2000-1 Addison Circle
Roundabout Research - 1996

Re: Addison Circle Phase I - Outstanding Issues

Addison Circle Phase I Public Infrastructure

Re: Addison Circle - Preliminary Plat/Construction Plans

Esplanade Park
Possible Conflict of 4" WW w/ Exist. 72" RCP

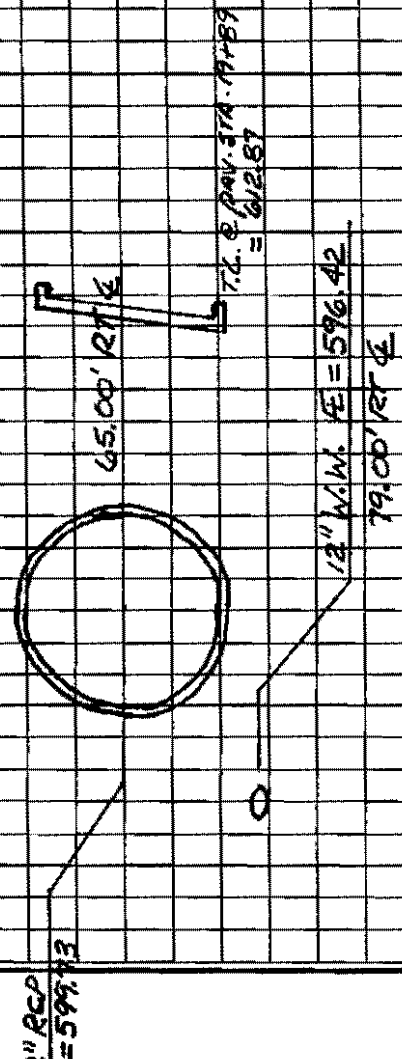
F/L of 12" WW is 3.31' below the F/L of the 72" RCP @ the proposed tie-in

INTERSECTION DESIGN STANDARDS: MAJOR FOUR-WAY INTERSECTION

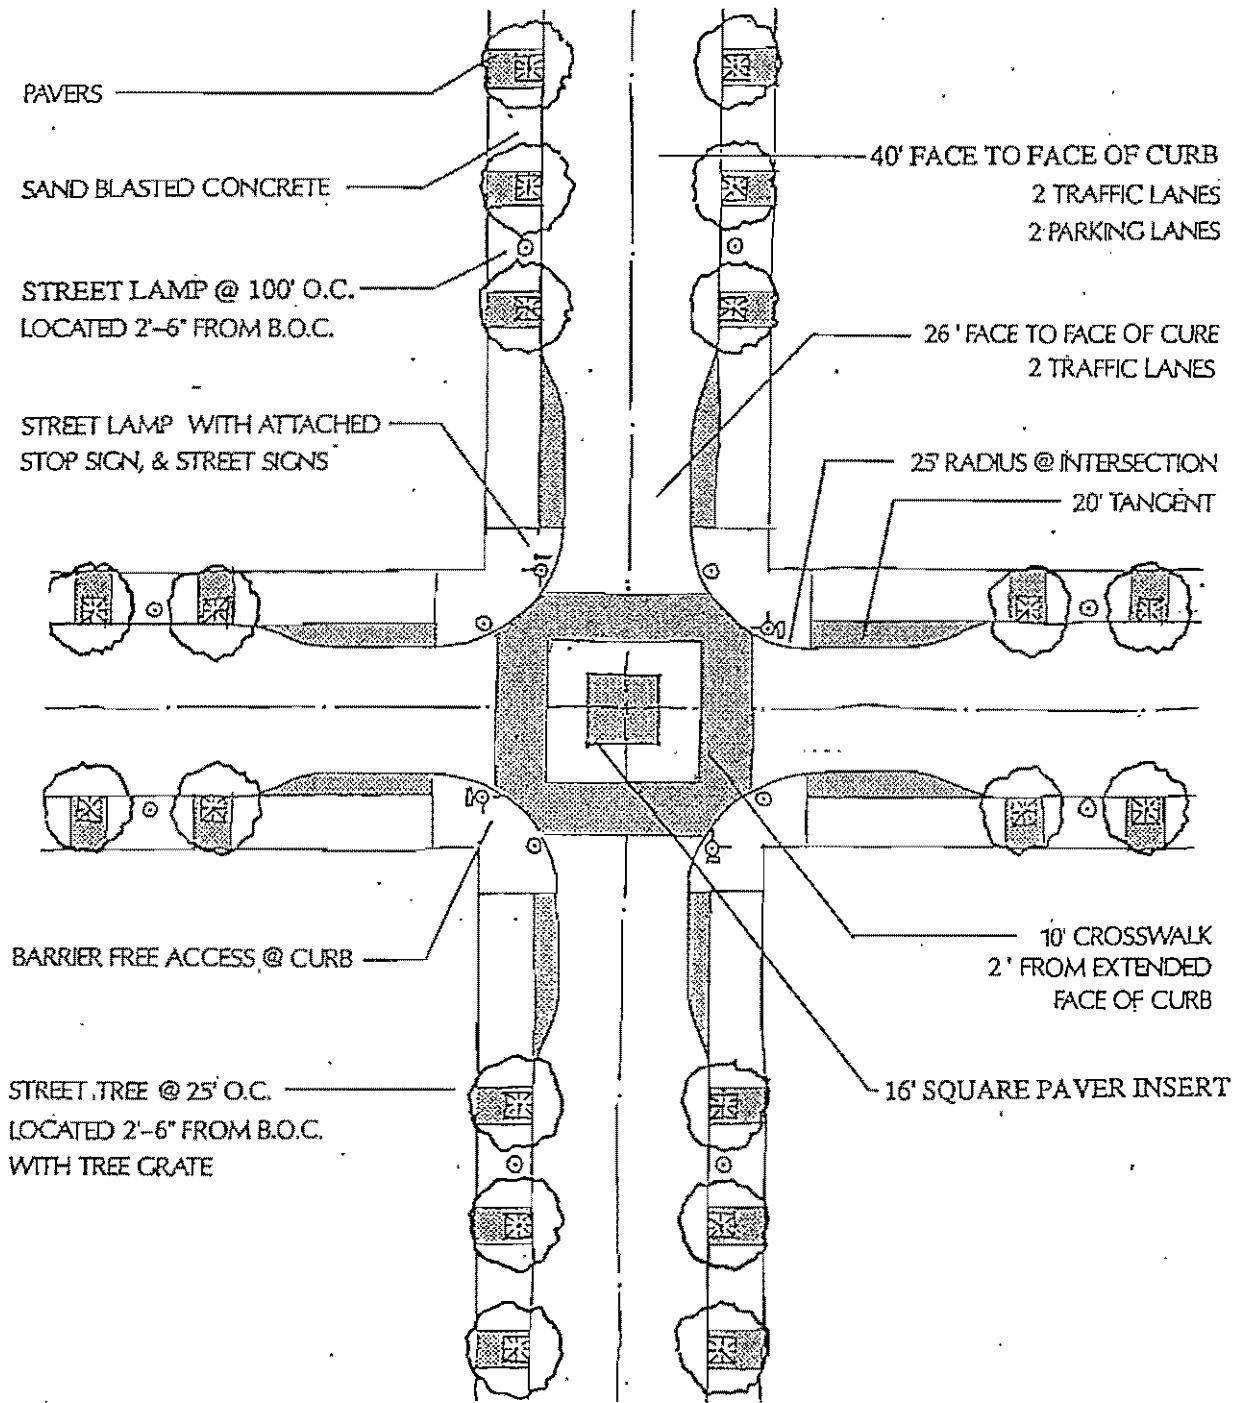
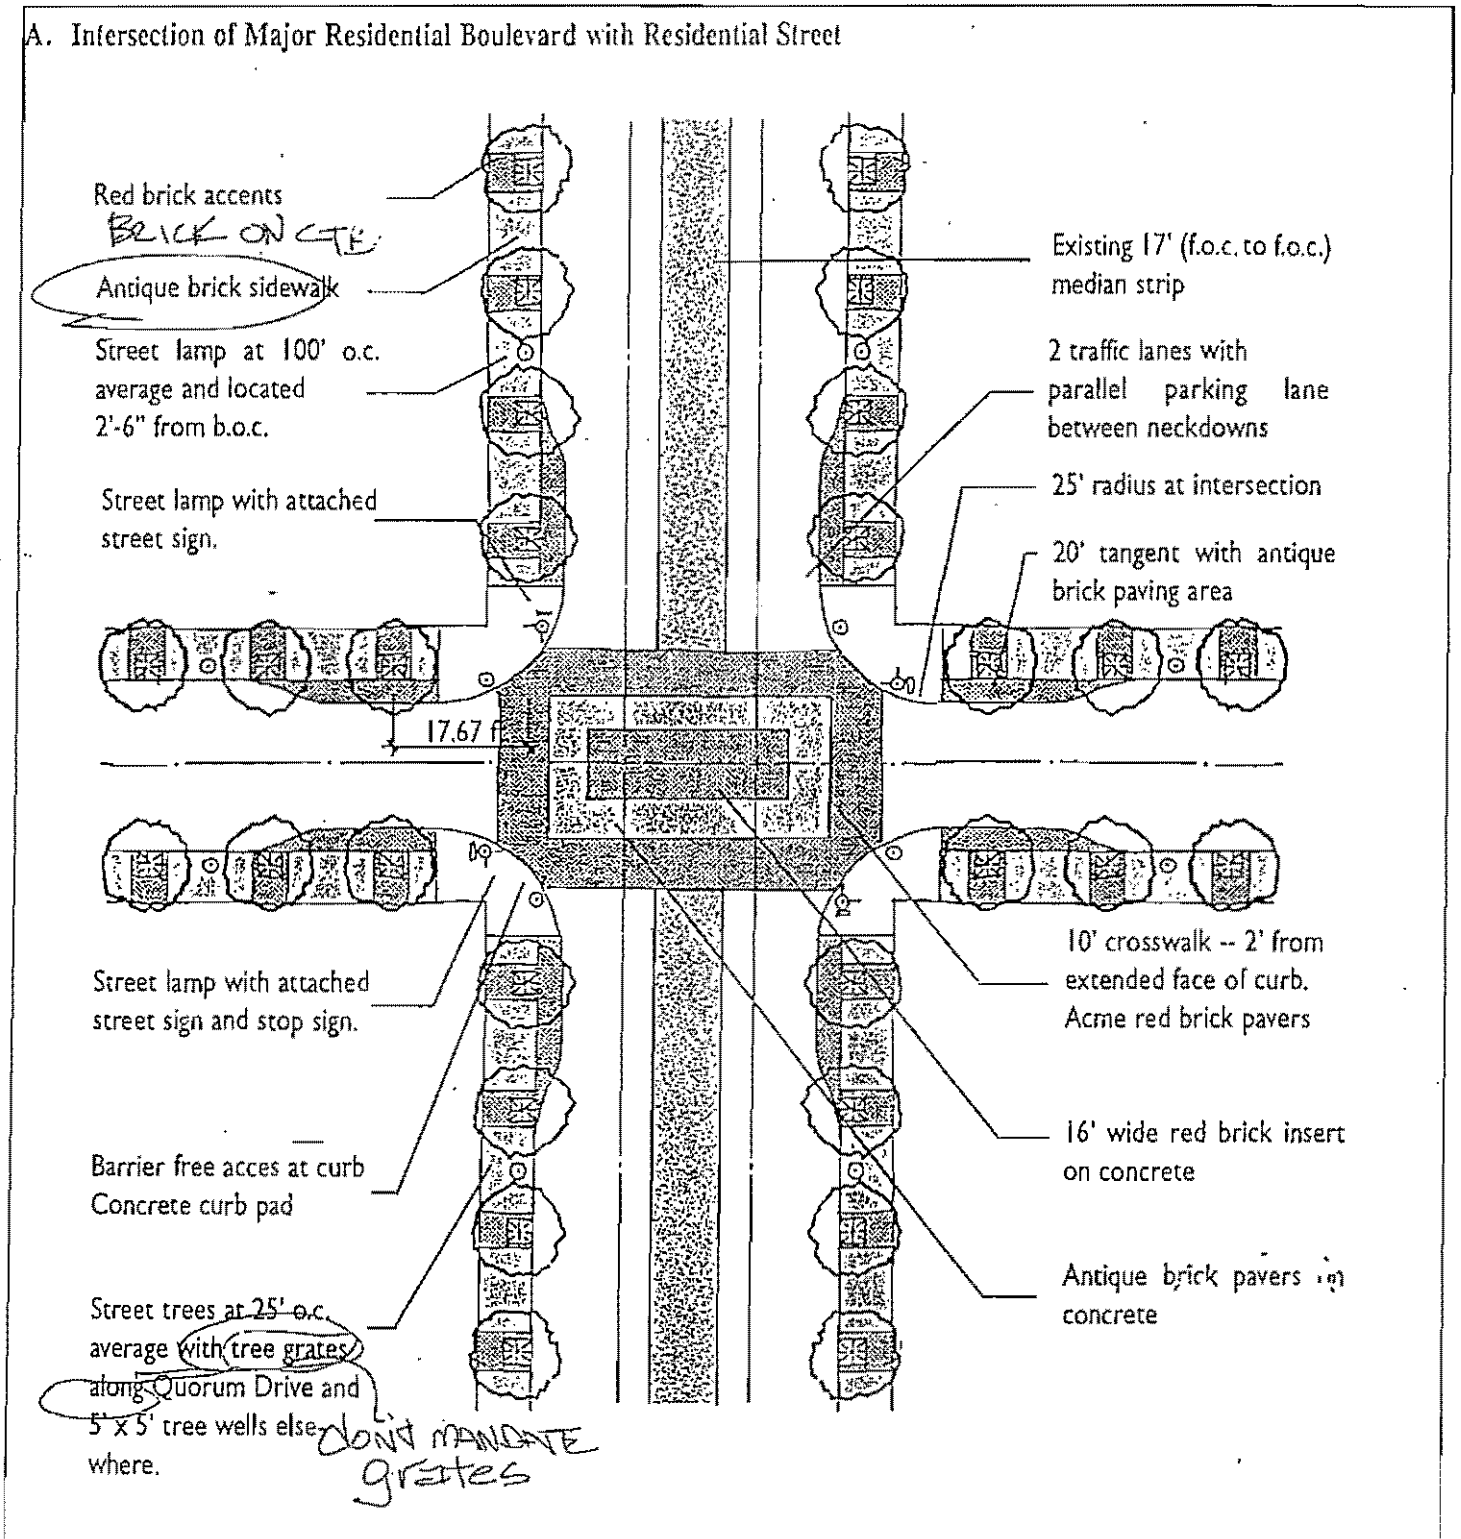
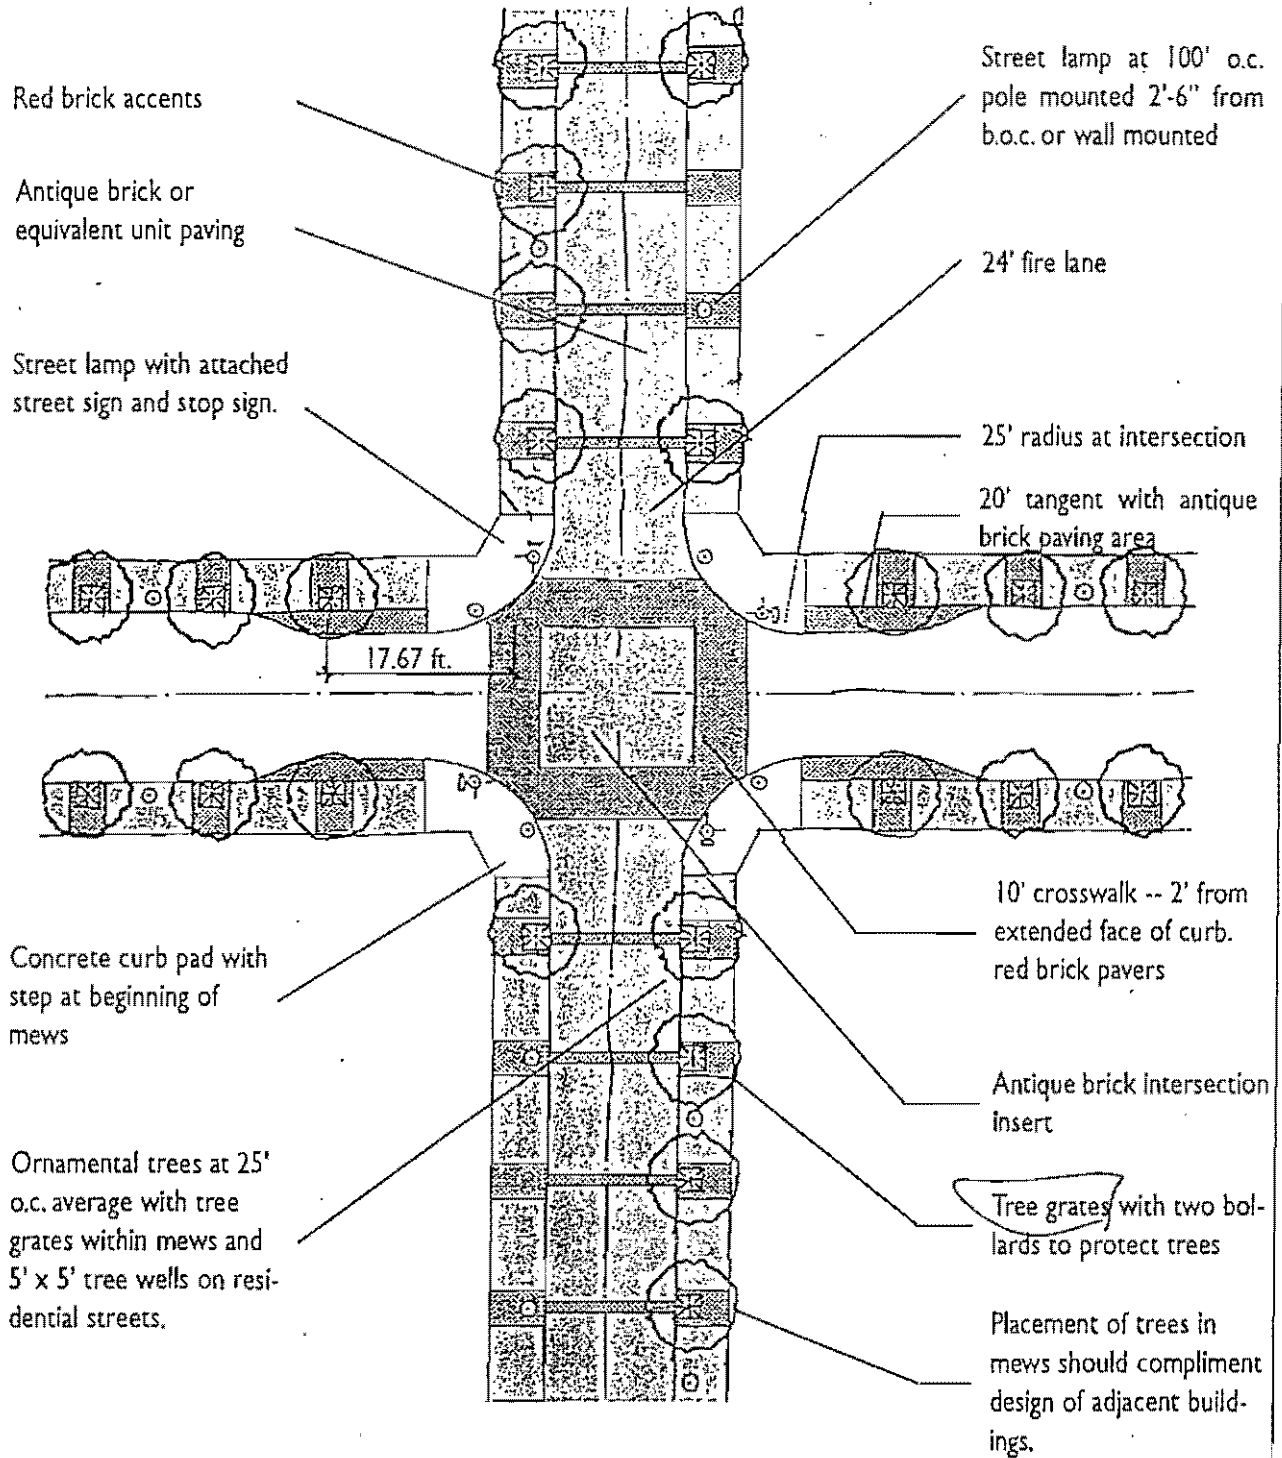
Not antique brick
